UNITED STATES ENVIRONMENTAL PROTECTION AGENCY

Arconic/Alcoa West Plant - Massena, 45 County Route 42 (Park Ave East)

EPA Inspection August 30 to September 1, 2017

Compliance Evaluation Inspection - Massena Operations - Alcoa/Arconic West Plant

DSCN4858 - 001 Outfall Booms in Grasse River

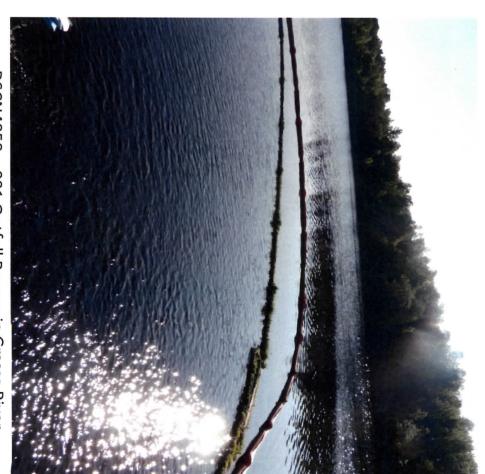
Outfall	Observation	Photos	Area of Concern (Y or N)
001	As shown in photograph 858, Attachment 1A, the boom at Outfall 001 was said to be changed quarterly. As shown in photo 858 the inner boom had much vegetative growth. Please verify the cleaning and changing frequency for the booms. Alarm for outfall (dialer) has been disconnected because control room was receiving unwarranted alarms. Paper rolls in flow were missing since Feb. 2017 for the river monitor.	858	Y – Alarm Dialer disconnected. Frequency of boom maintenance
003	Outfall 003 (18" Parshall Flume) had two head sensors to measure submerged flow Ha/Hb. The flow charts for the outfalls did not include a chart for head and submerged head, only a chart based on the head in the converging section of the flume. Does	859 to 861	Y – Does diverging section of flume become submerged?

DSCN4883 - 004/005 impoundment

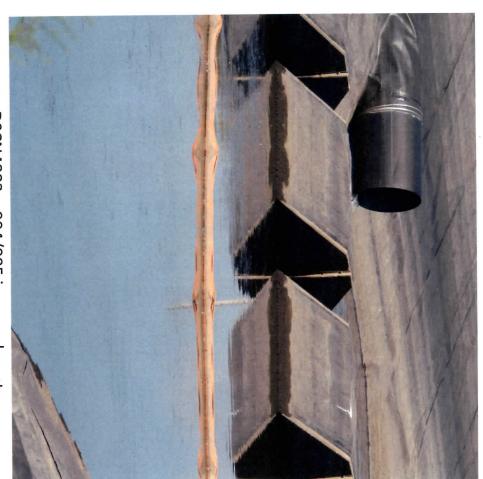
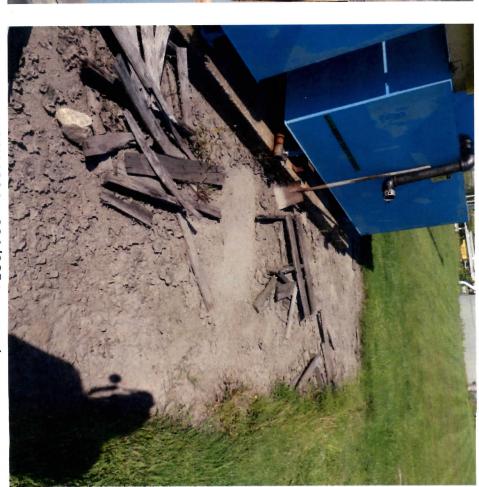
9. The Outfall 004/005 Impoundment (photos 882 to 884) was said to be designed for a 19 year storm, and overflows at a height of 17'. Based on the letter from Arconic (excerpt below) it overflowed in July 2017. The letter indicated that there was a violation due to dewatering of central impoundment as well. Special Condition O of the Permit authorizes discharges from 005 and bypasses of the 004 carbon unites when stormwater runoff exceeds the design storm. The design storm was thought to be a 19 year storm. Please verify whether the 004/005 system is designed to handle the 25 year storm, or if additional capacity is needed in this system.

DSCN4885 — Outfall 01G- Bldg 140. sediment accumulated in need of cleaning

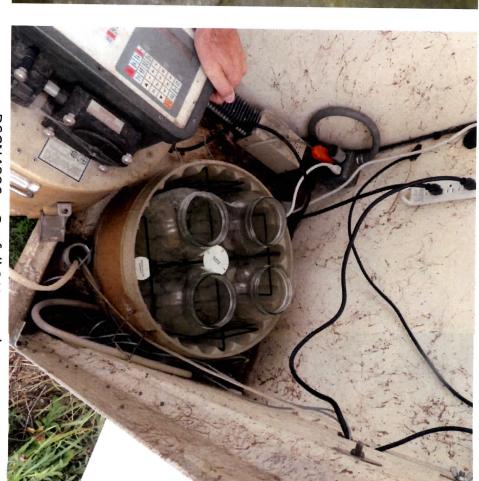
01B	Oil Wastewater Treatment – Area III O/W separator.		N
	Pump 1 VFD was out of service. Said that there was a replacement available and new pump would be installed the following week. Arconic representatives indicated that they are considering additional treatment for 01G or expanding the 004 lagoon. As shown in Photo 884 in Att. 1a there was soil and pallets at the 004/005 impoundment that should be cleaned up.		Y (Status of Pump 1 and other pumps for 004) Status of 01G treatment or 004 lagoon expansion.
			debris at 004/005 impoundment.
007	No Flow through 4.5' H FLume	879, 881	N .
01G	Outfall 01G (heat treat waters from Area I) was said to flow to 004 but the permit specifies that Outfall 01G flows to Outfall 001 - 01G consists of the Bldg. 131 and 140 separate discharge		Y – remove sediment from 01G-140

DSCN4902 – 01E clarifier, weirs have growth on them

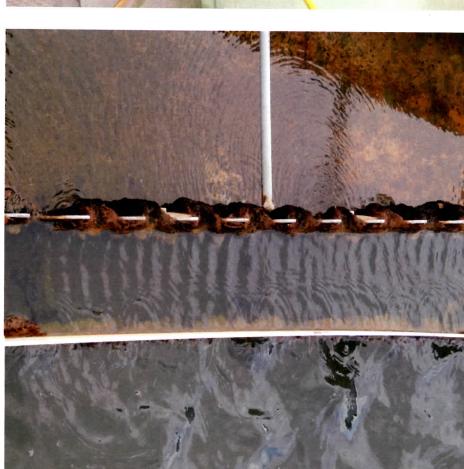
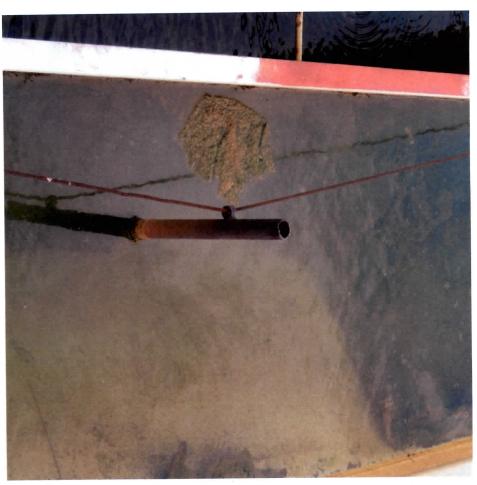
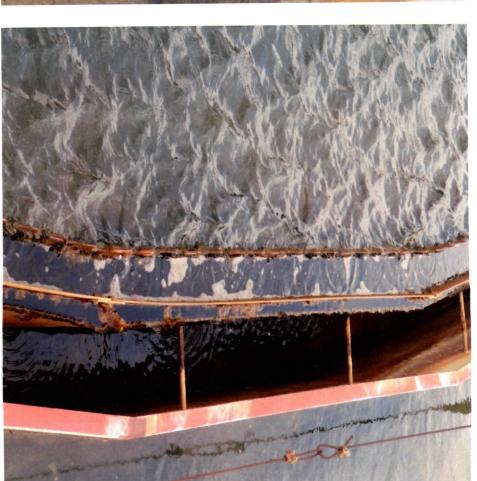
Outfall	Observation	Photos	Area of Concern (Y or N)
	in September (by Alcoa). The Area II BMP Checklist for June 28, 2017, (Att. 5) identified that the ingot wastewater settling wells were due for cleaning.		ventilation fan status.
	Composite Sampling Refrigerator Temperature was 15 deg. C (high temp), and was not working. Arconic employees explained that they put bagged ice in the composite sampler. Said that sampling conducted in first two weeks of month.		Status of cleaning ingot wastewater settling wells.
	Exhaust fans were not properly operating in outfall building. There is a bubbler and an ultrasonic flow meter at 01E. The bubbler is being used for flow reporting and the ultrasonic used for polymer feed.		Clean clarifier floating material and accumulation on weirs — need to ensure
	As shown in the photos there was an accumulation of floating material in the clarifier and growth attached to the weirs. Facility representatives explained that sludge had not been removed from the clarifier since 2007.		proper O&M. of clarifier and proper sludge removal.

DSCN4908 – material storage piles

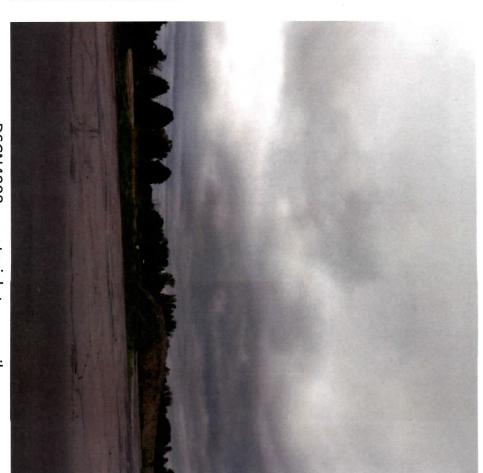
- 4. As shown in photographs 866, 909, 910 there are uncovered and unstabilized material storage piles. Arconic employees explained that material storage piles would be used to cover concrete areas and not be ripping up the concrete. The area that they will be applying soil was greater was estimated to be over an acre. Arconic is required to develop and implement a Stormwater Pollution Prevention Plan (SWPPP) as required by Special Condtion 4.B of its Permit for construction activities 1 acre or greater. Arconic employees said that they don't need SWPPP because they will be applying the soil from the piles on top of concrete and not ripping up the concrete. However, the application of soils over an area 1 acre or greater would trigger the requirement to develop and implement a SWPPP.

DSCN4911 – remedial group cover soil – tarp not fully covering soil

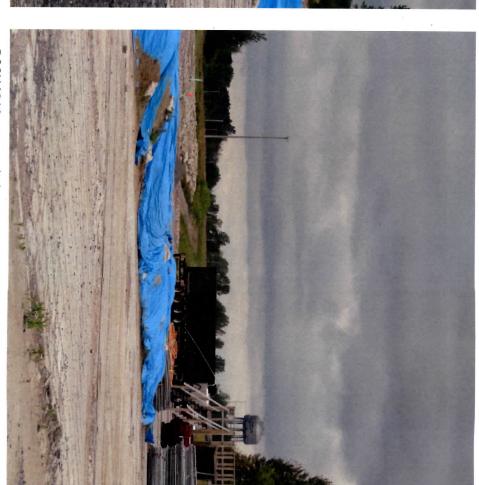
As shown in photos 911 and 912 there is a material storage pile with a blue tarp covering most but not all of the pile that was to be used for cover material by the remedial group. This material storage pile must be kept covered and proper erosion and sediment controls developed under its Best Management Practices (BMP) Plan Special Condtion 4.A.11

(Erosion and Sediment Control and/or SWPPP. Arconic representatives said that they would make sure those piles are kept covered.

DSCN4916 – Alumina Dust near pot line at the southern end of Alcoa courtyard

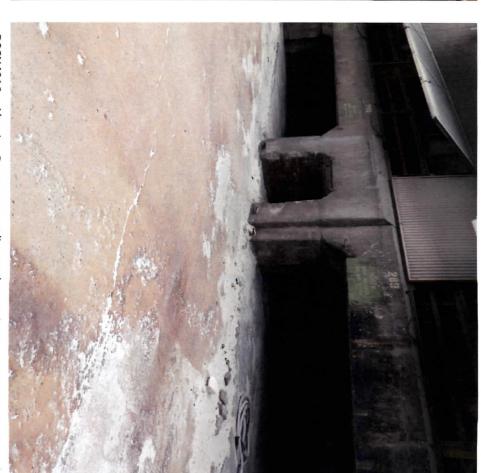
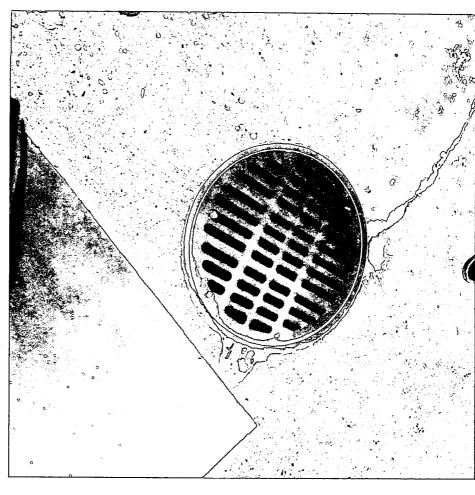
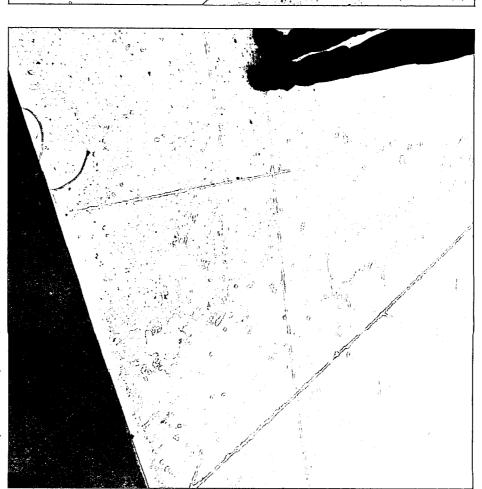
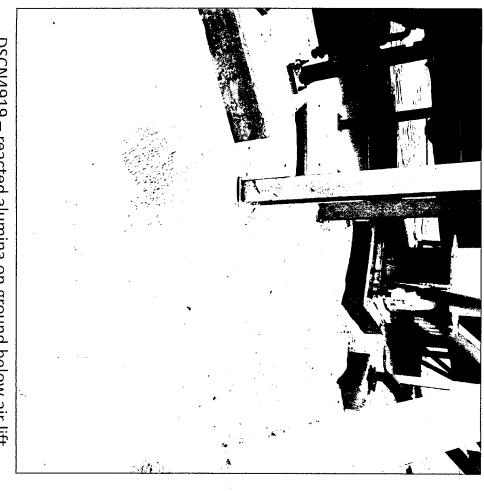
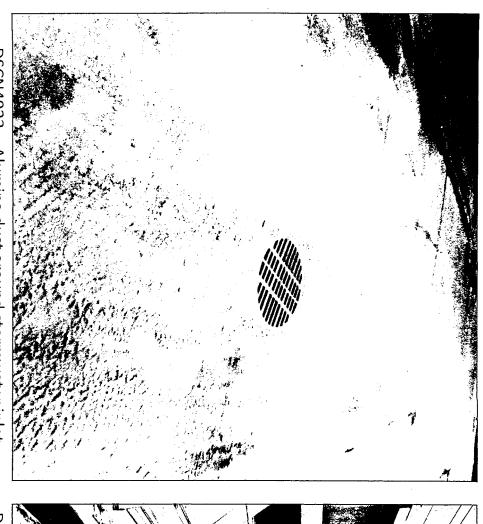
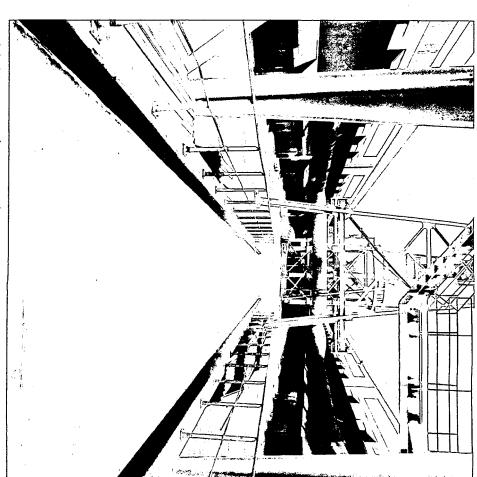
^{8.} During the inspection, we also visited the pot line area owned by Alcoa, but ultimately discharges under the Arconic SPDES Permit. As shown in photos 916 to 924 there was Alumina dust around stormwater inlets and in many places in the yard due to leaks of

alumina from leaking air slides, air lifts and other sources. The Best Management Practices Plan portion of the Permit and the BMP Plan for the facility does require good housekeeping and preventative maintenance for this area. The Area III BMP Checklist in house inspection dated July 24, 2017 identified poor housekeeping in Area III potline courtyard area. And also identified that stormwater inlet controls (drain pyramids) were installed on some inlets. It did also identify numerous leaks in the alumina conveyance system. Similar findings were made in the June 28, 2017 Area III BMP Checklist. (Attachment 4)

Alcoa representatives said that they sweep the courtyard twice per week, but sweeper had been broken for 2 days and said that stormwater inlets are vactored once per quarter Improved housekeeping and repair of leaking equipment is needed in this area.
